DETERMINATION REPORT

OJSC "SUKHOLOGSKCEMENT"

**DETERMINATION OF THE
"NEW DRY CEMENT LINE INSTALLATION
AT OJSC "SUKHOLOZHSKCEMENT",
SVERDLOVSK AREA, RUSSIA"**

REPORT No. RUSSIA-DET/0035/2009
REVISION 02

Figure A.2.1: Baseline and project capacity

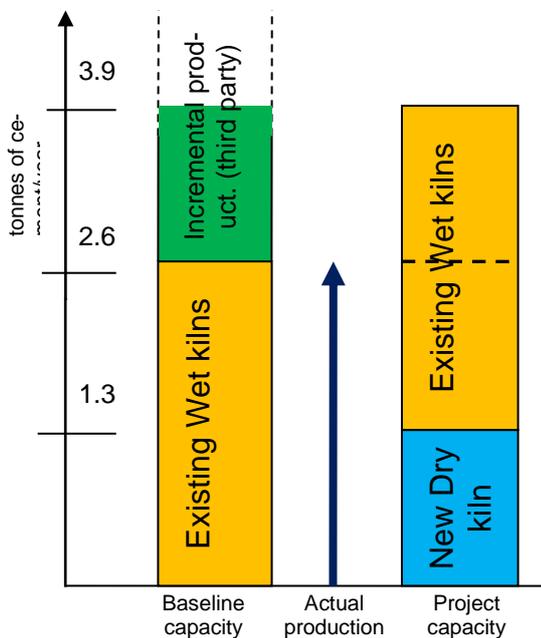
<p>than 2.6 mln t then, in the baseline scenario, a deficit capacity forms which would have been covered by third party cement producers (incremental capacity). This situation is elaborated in PDD in sufficient detail. However, the emission reductions are estimated for the project scenario with maximum capacity 2.3 mln t to be achieved in 2012 and thus with the incremental capacity of third party cement plants equal zero.</p> <p>Project will result mainly in fuel consumption reduction and therefore in CO2 emission reduction.</p> <p>The history of the project and the situation existing prior to the starting day of the project is summarized as required in [2].</p> <p>CAR 02. Section A.2 in PDD exceeds the limit of 2 pages [2].</p> <p>CAR 03. There is no consistency in the description of the project scenario as regards the cement production capacity between Subsection "Project Scenario", Subsection "Baseline scenario" and Fig. A.2.1.</p>
